August 25, 2023

Project Name: Madison County Schools - New Tennis Complex

Project Number: 23-034

ADDENDUM NO. 04

1
E301
**ELECTRICAL SERVICE & DISTRIBUTION SYSTEM
SCHEMATIC POWER RISER DIAGRAM**
NO SCALE

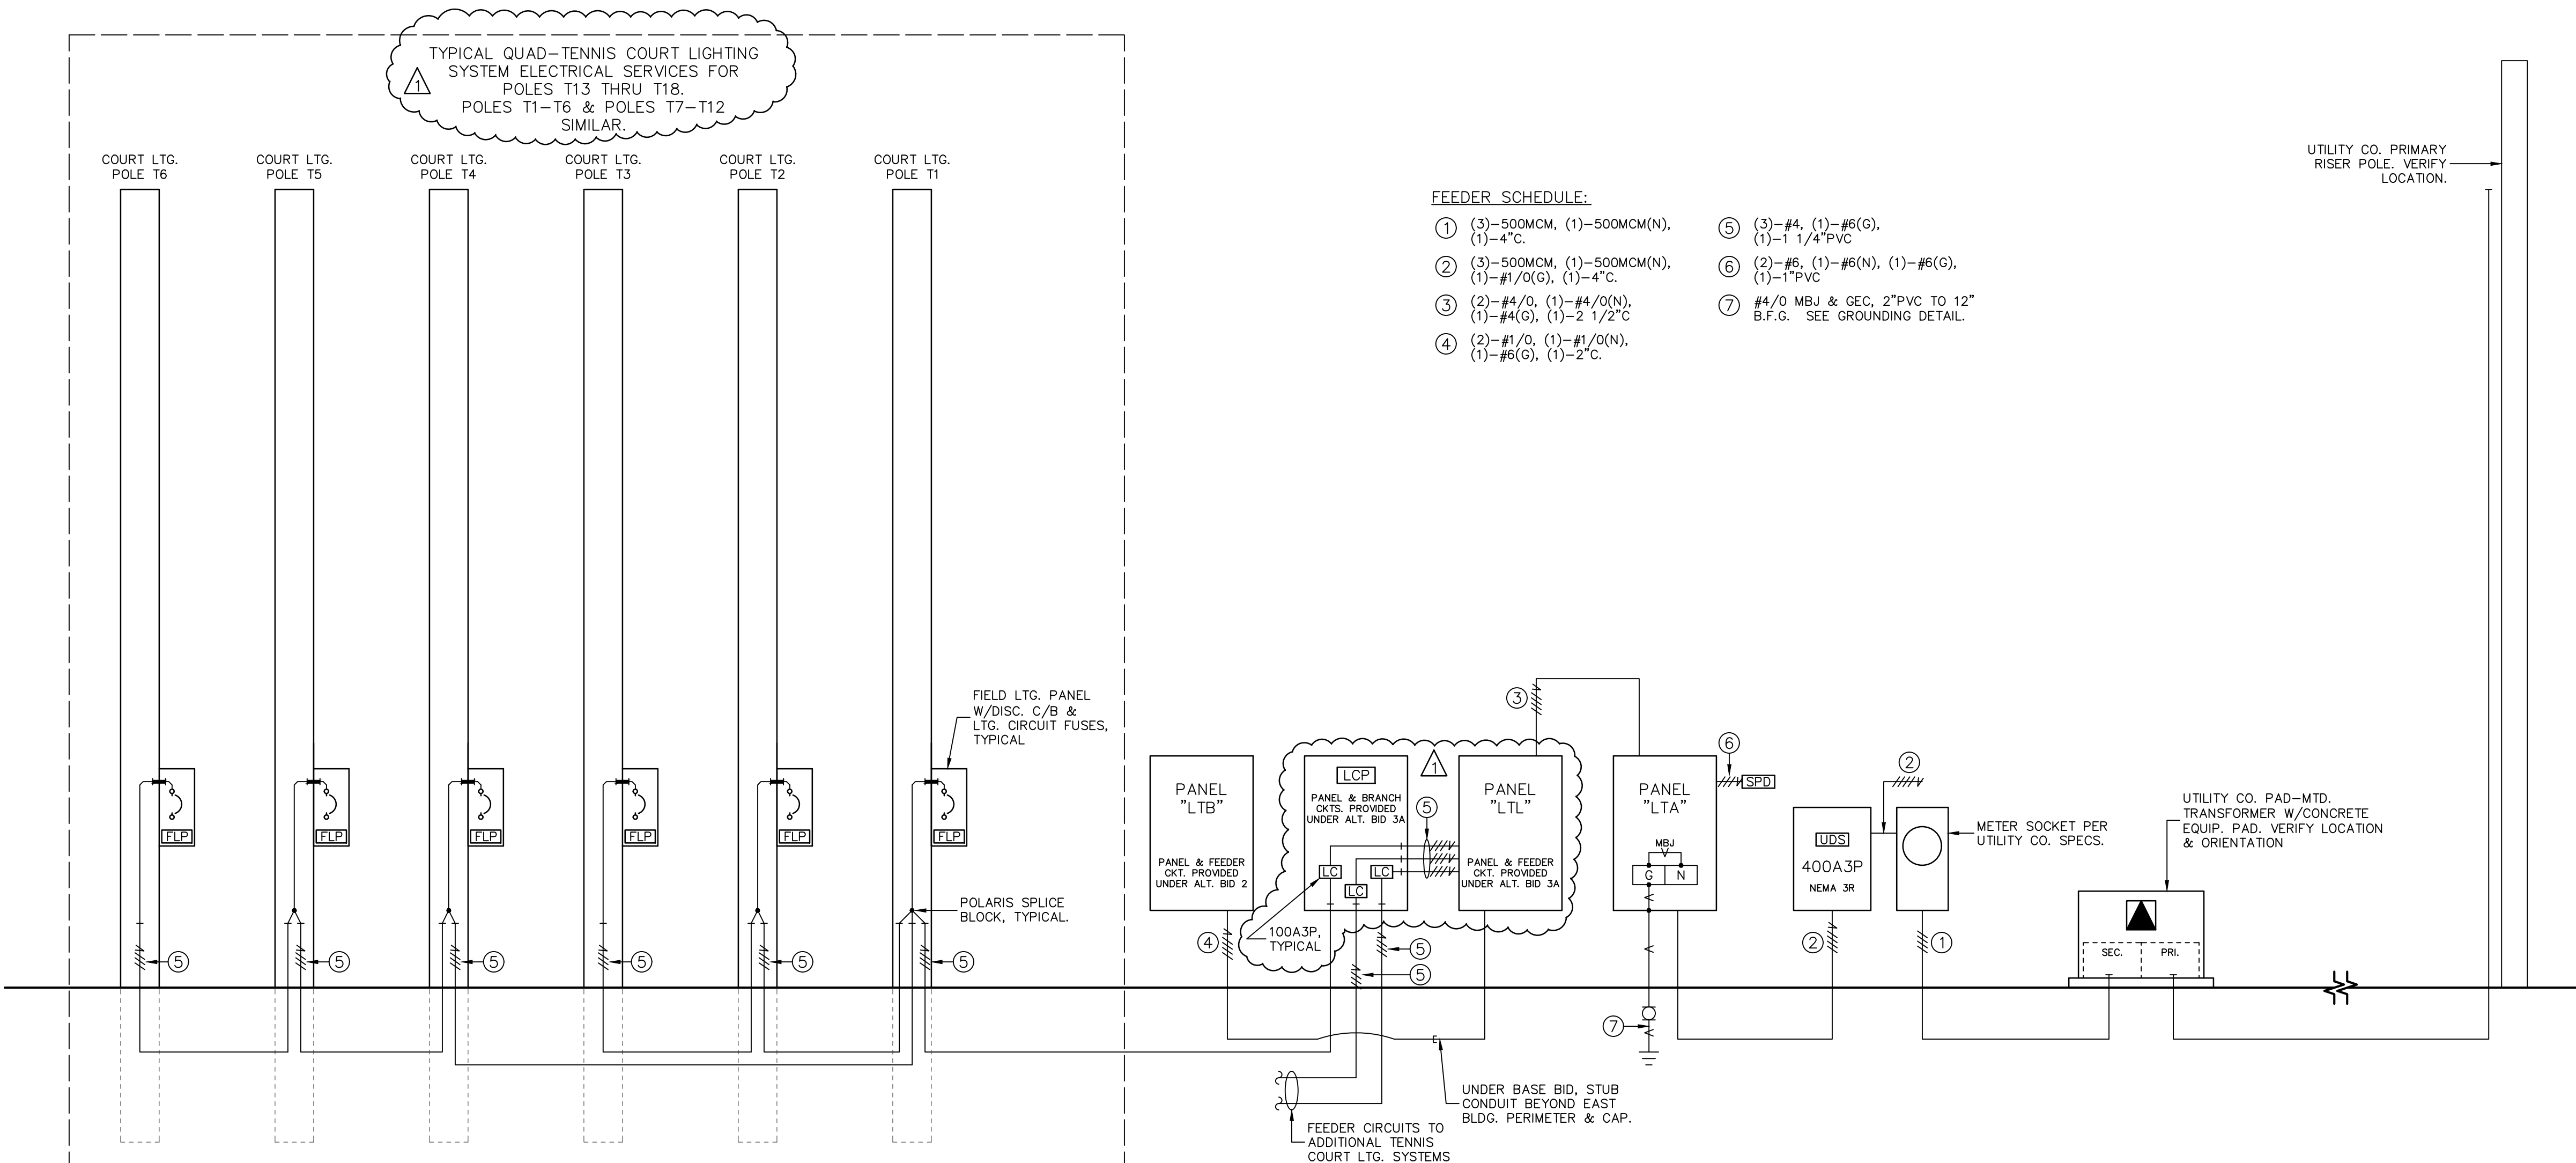
REPLACE sheet **E301**, with the attached **revised E301**.

Clarification: Drawing makes revision to the Electrical Service & Distribution system to meet the requirements of the Court Lighting system and to clarify work to be included in Alternate 3A.

1
E401 NOT TO SCALE
**TYPICAL COURT LIGHTING POLE
GENERAL LAYOUT & MOUNTING DETAIL**

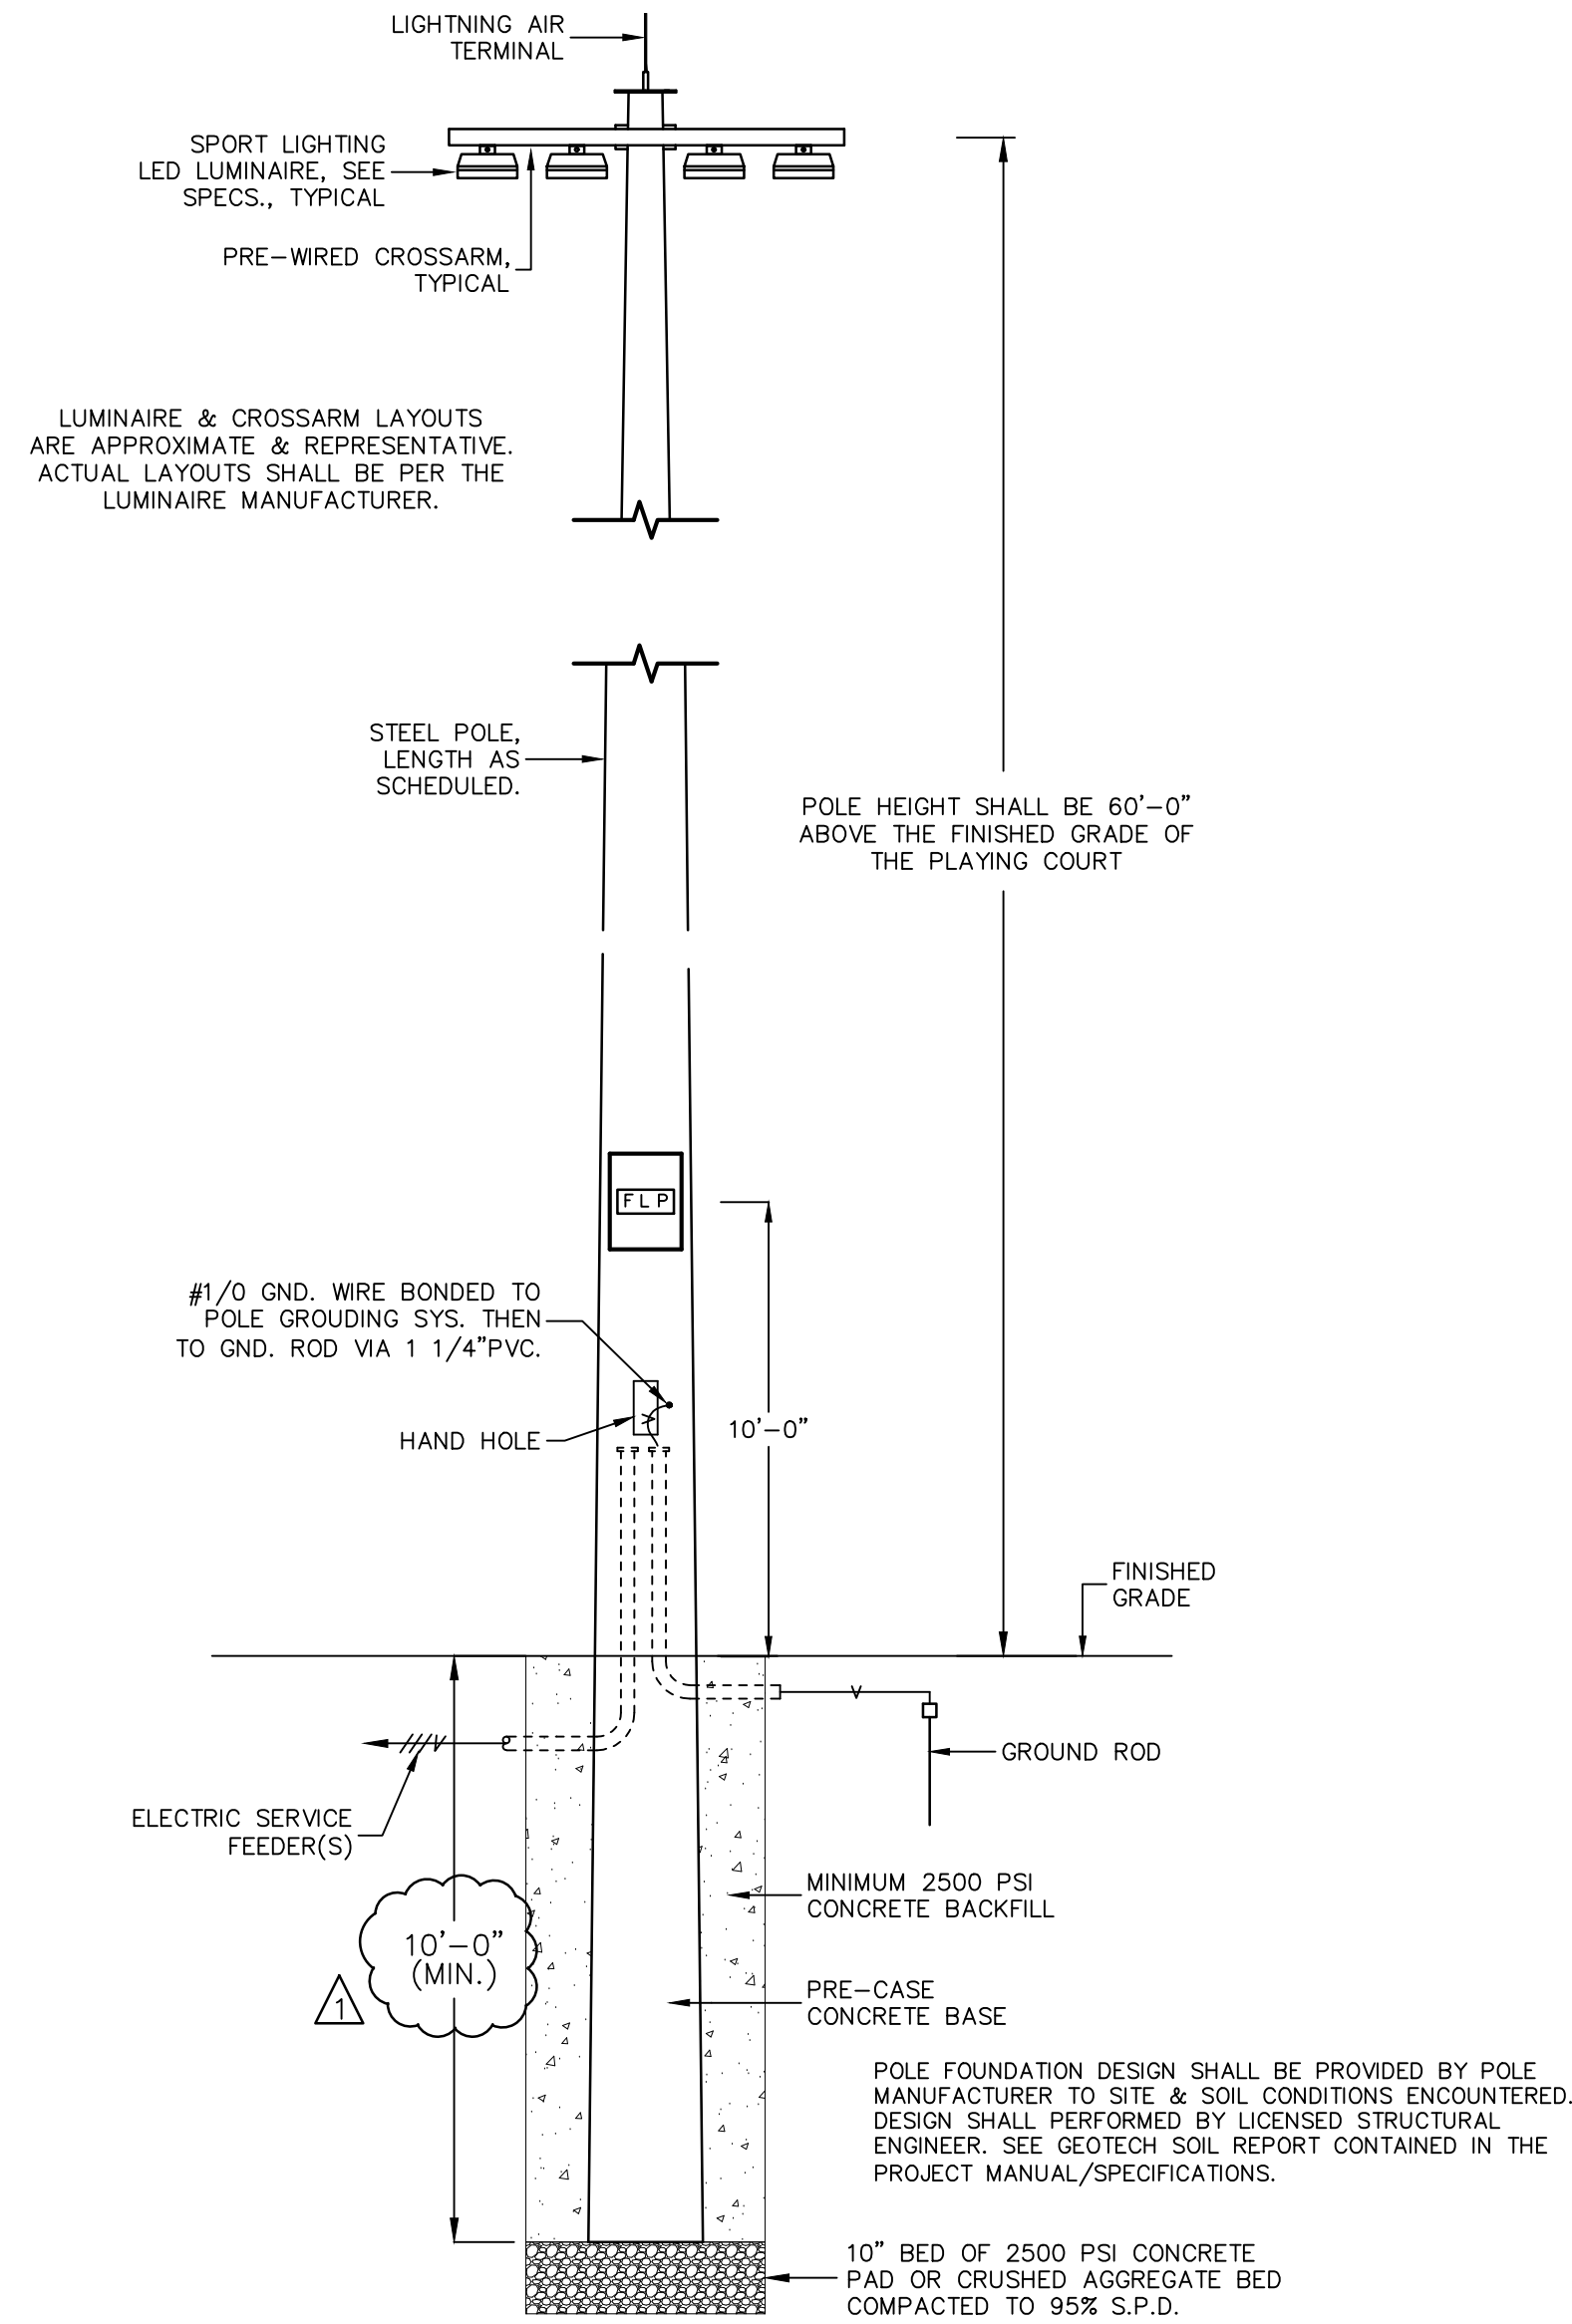
REPLACE sheet **E401**, with the attached **revised E401**.

Clarification: Revised drawing indicates poles and luminaires to be included in Alternates 3A or 3B.
